# A47 Wansford to Sutton Dualling

## **9.32 Applicant's Response to the Examining Authority's Third Written Questions (ExQ3)**

**9.32 APPLICANT'S RESPONSE TO THE EXAMINING  
AUTHORITY'S THIRD WRITTEN QUESTIONS (EXQ3)**

<b>Rule Number</b>	Rule 8(1)(c)
<b>Planning Inspectorate Scheme Reference</b>	TR010039
<b>Application Document Reference</b>	TR010039/EXAM/9.32
<b>BIM Document Reference</b>	PCF STAGE 4
<b>Author</b>	A47 Wansford to Sutton Project Team, National Highways

## **ANNEX B - Drawing HE551494-GTY-HGN-000-DR-CH-38004**

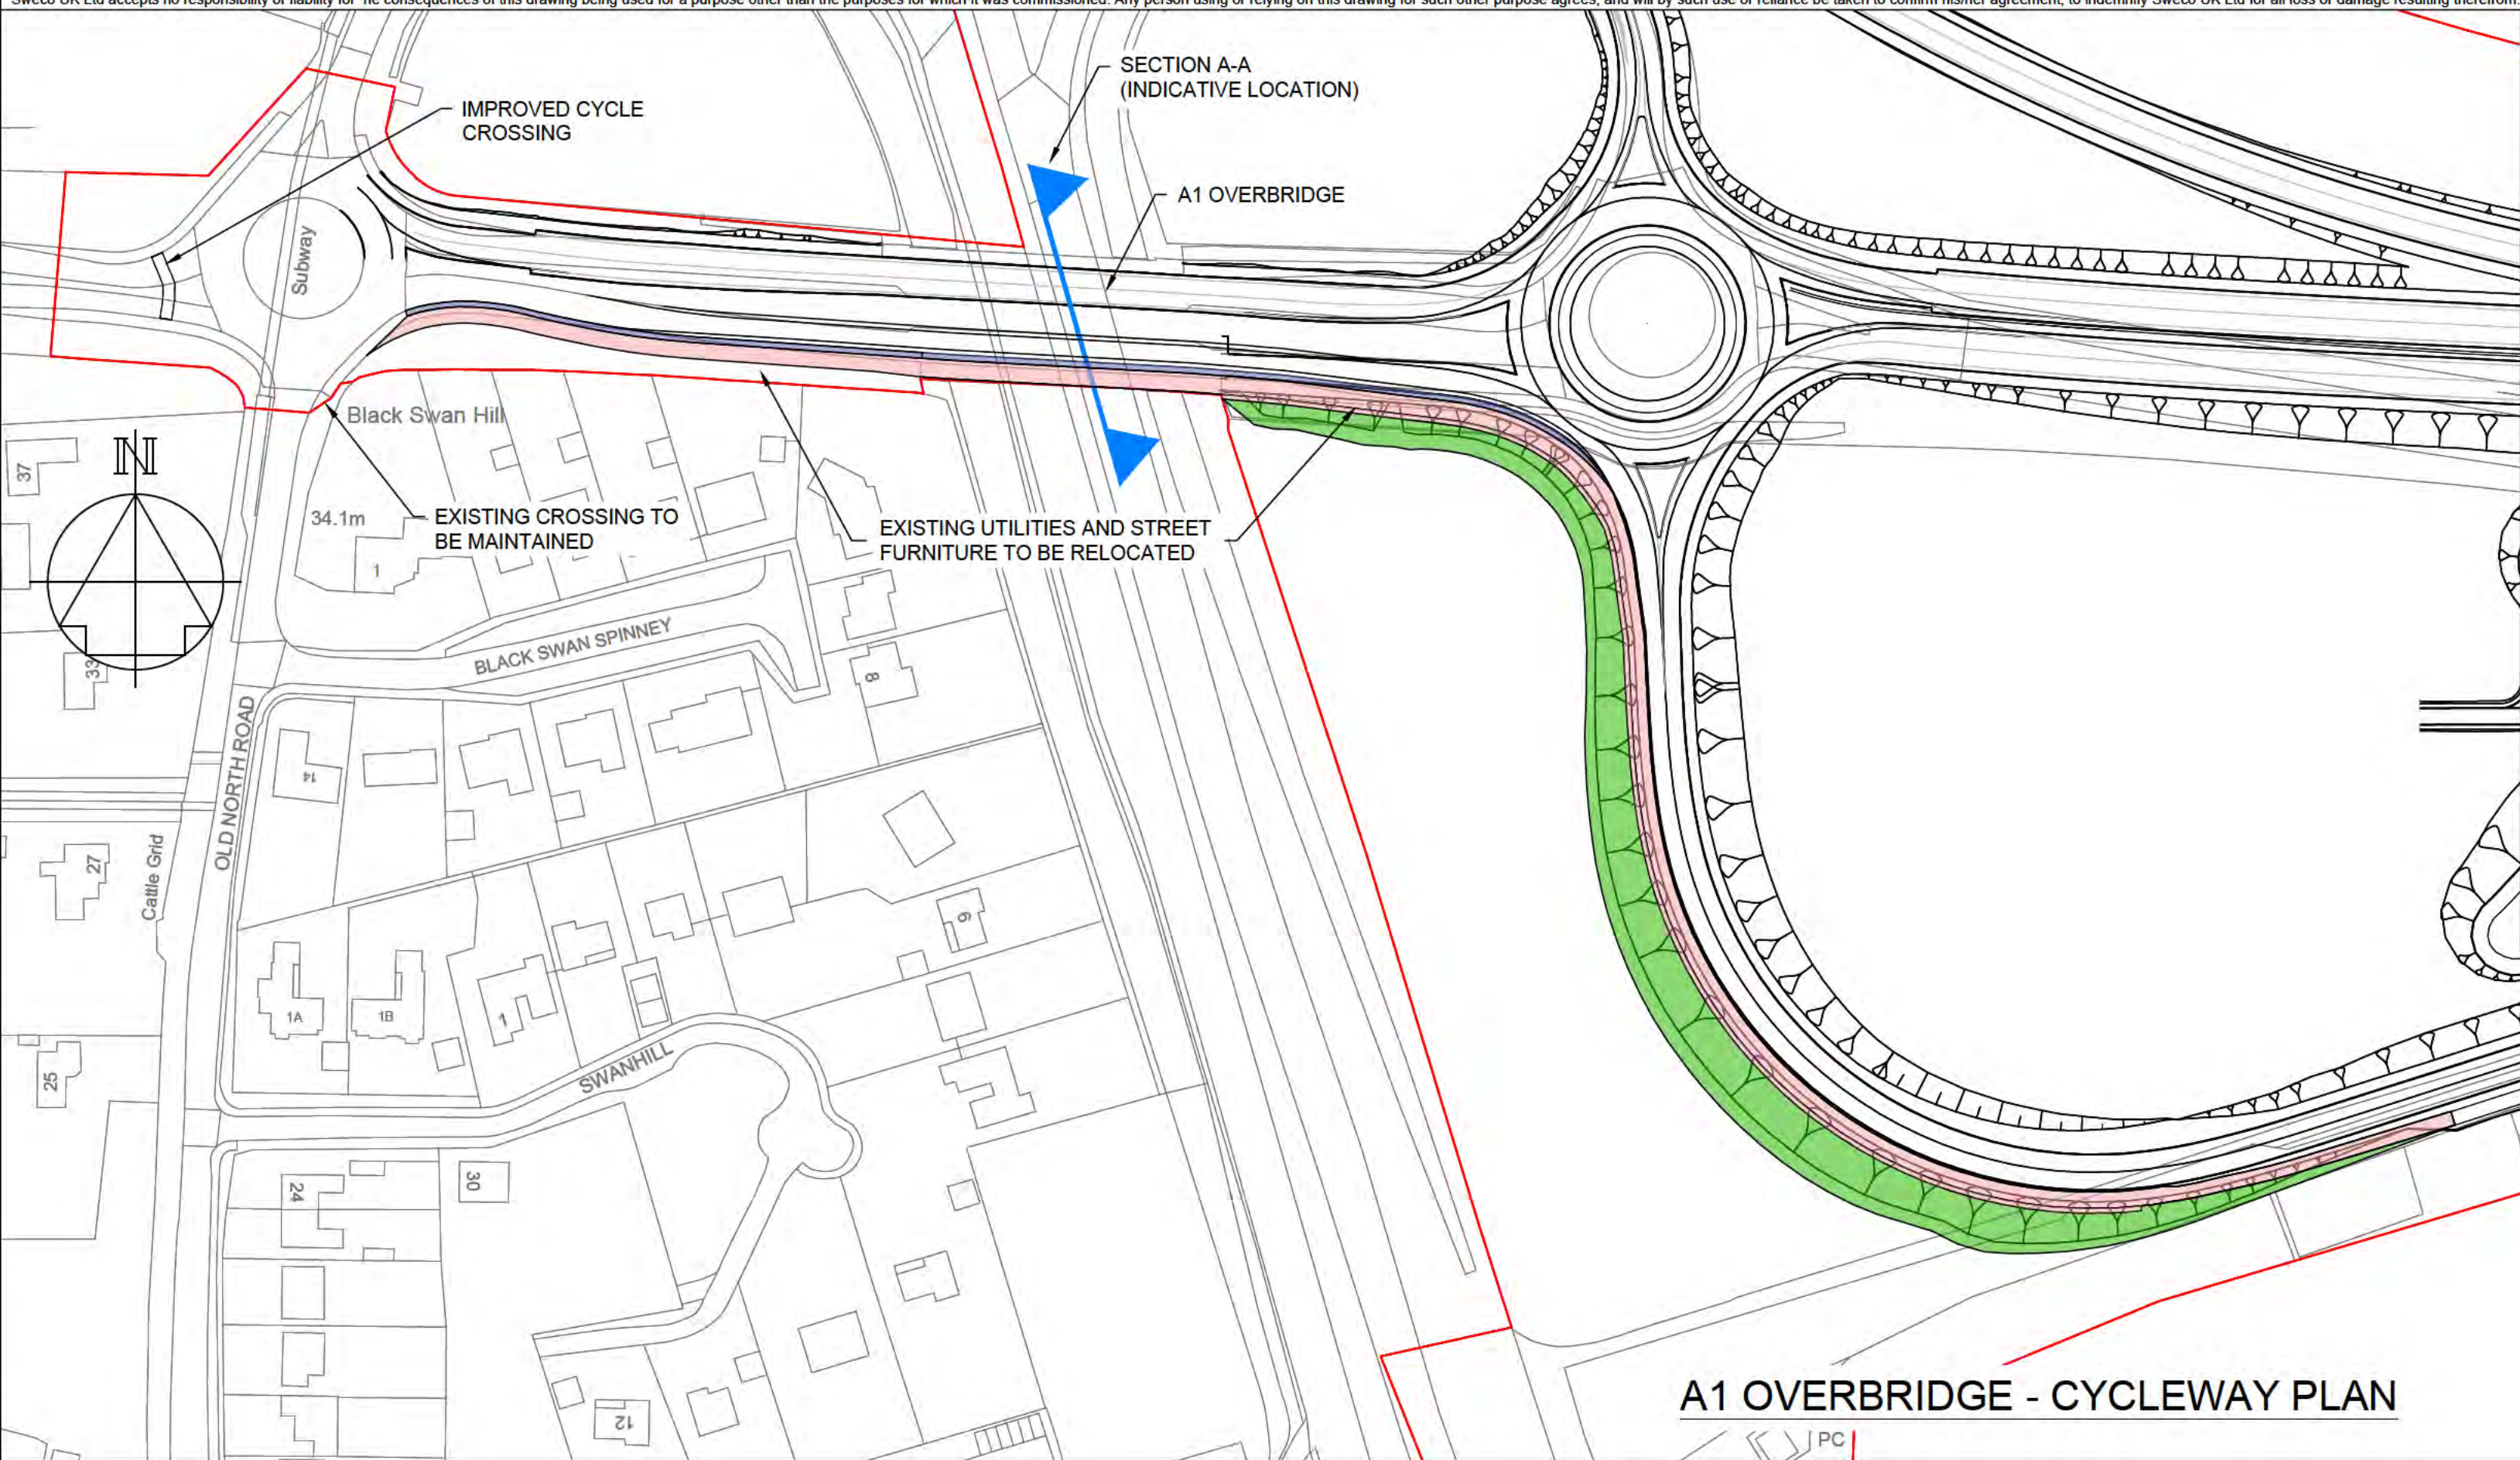
3.11.5	The Applicant	<p><b>NMU Route in southwest of Application site</b> In the Legal Note on Wansford Nene Way Permissive 1, the Applicant refers to Options 1a and 1b as shown on Drawing HE551494-GTY-HGN-000-DR-CH-38004. Could this drawing please be provided?</p>	This drawing has been provided as Annex B to this document.
<p><b>3.12 Water environment and flood risk</b></p>
